## PLAN COMMISSION MEETING AGENDA

MONDAY, JUNE 09, 2025 AT 4:30 PM

**BUILDING SAFETY & ZONING DIVISION**  
**PLAN COMMISSION STAFF REPORT**

TO: Plan Commission  
DATE: June 9<sup>th</sup>, 2025  
SUBJECT: 411 Collage Ave, Conditional Use Permit - CUP

# CERTIFIED SURVEY MAP NO.

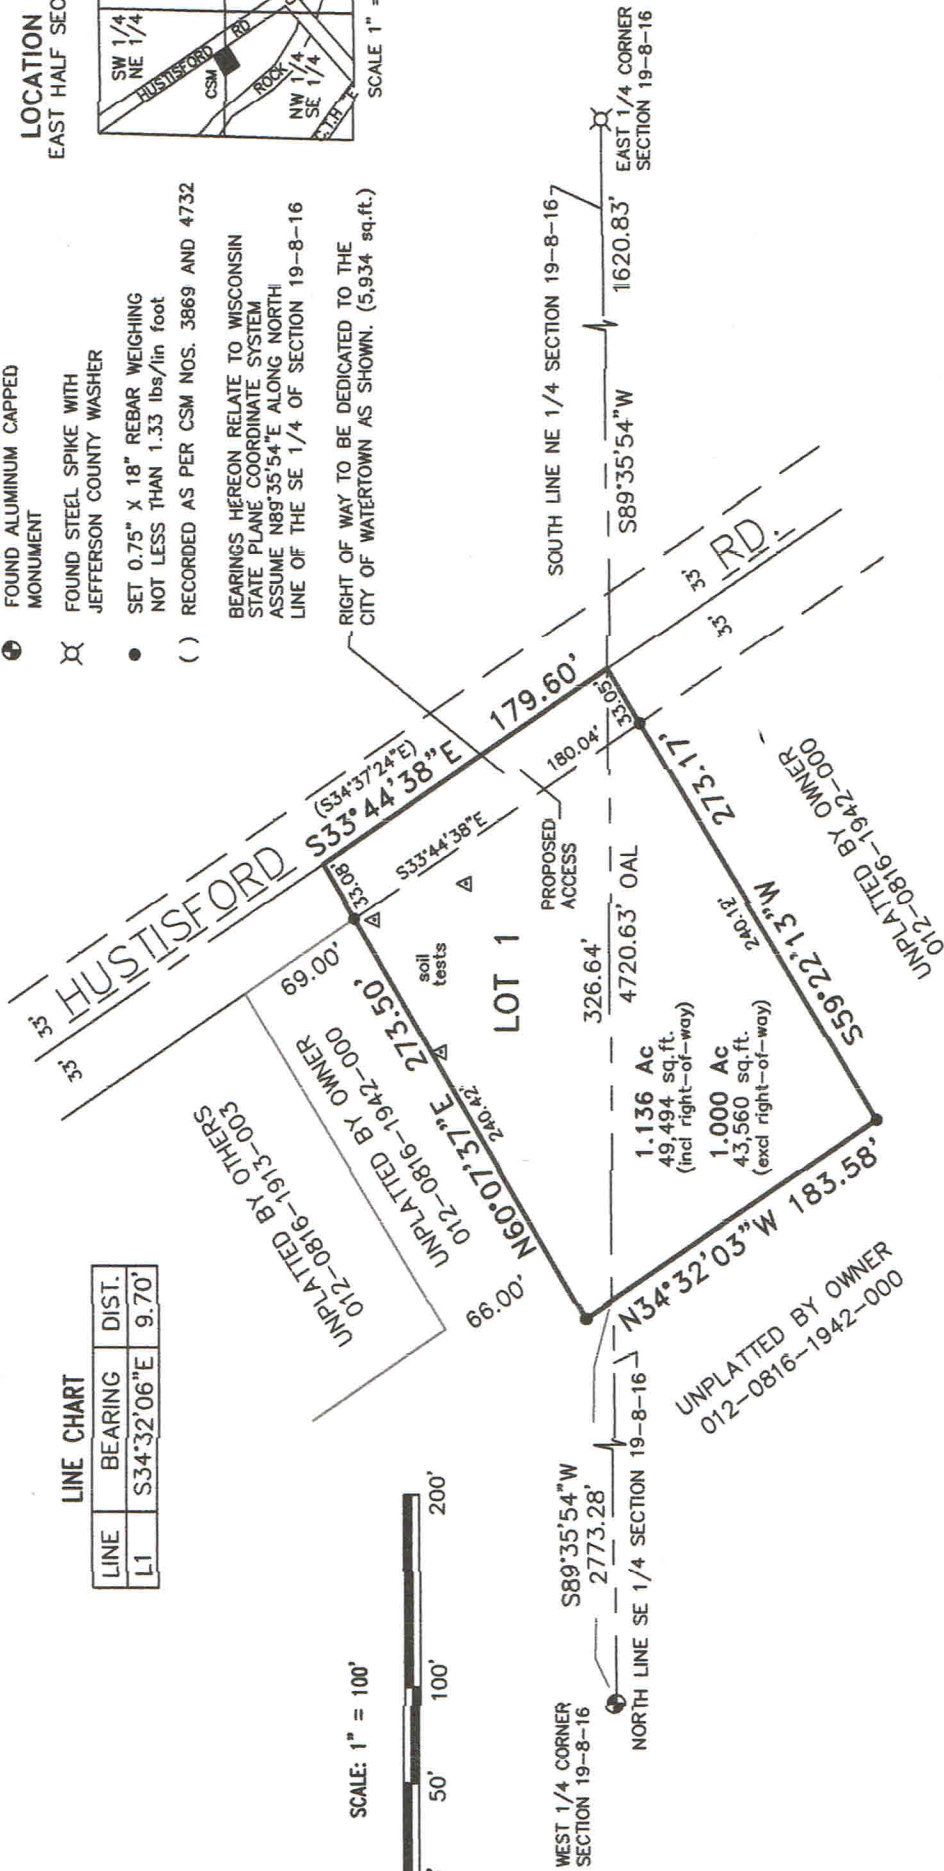
The proposed lot is not located within the Airport Approach Protection Zone. Hustisford Road is not identified in the 2019 City of Watertown Comprehensive Plan as having an expanded ROW. The existing 66 ft ROW is adequate for this location. The proposed ROW shown on the CSM should be shown as dedicated to the public.

1. Deny the preliminary extraterritorial CSM.
2. Approve the preliminary extraterritorial CSM without conditions.
3. Approve the preliminary CSM with other conditions as identified by the Plan Commission:
  - Correct the notation on the CSM indicating the Hustisford Road ROW is dedicated to the public not the City of Watertown.
